On-Site Wastewater Technical Advisory Group

October 7, 2020
Virtual Meeting

Meeting Summary

Recirculating Gravel Filter (RGF)

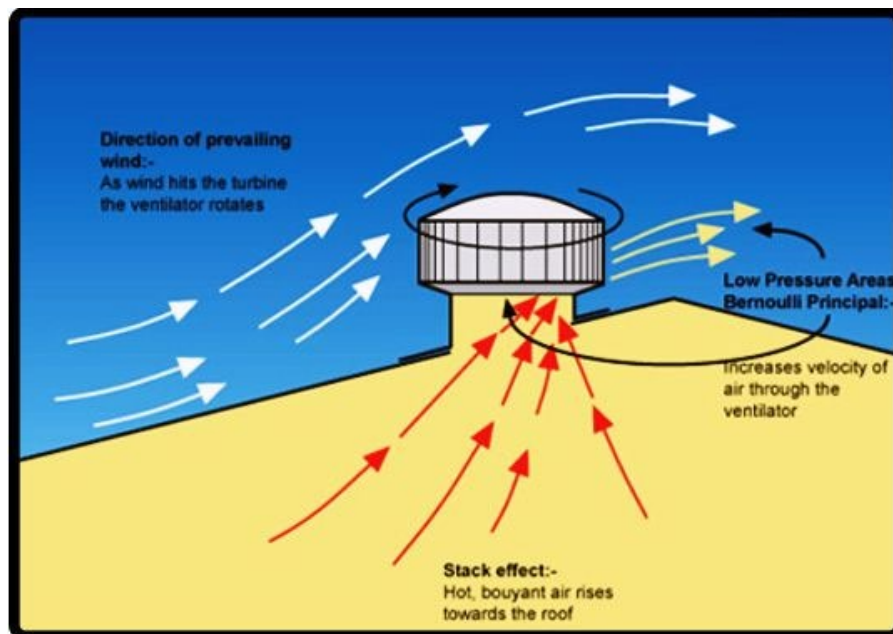
Several “field experience” boxes were added including new venting suggestions such as ventilator turbines. The following illustration will be added to the text box:
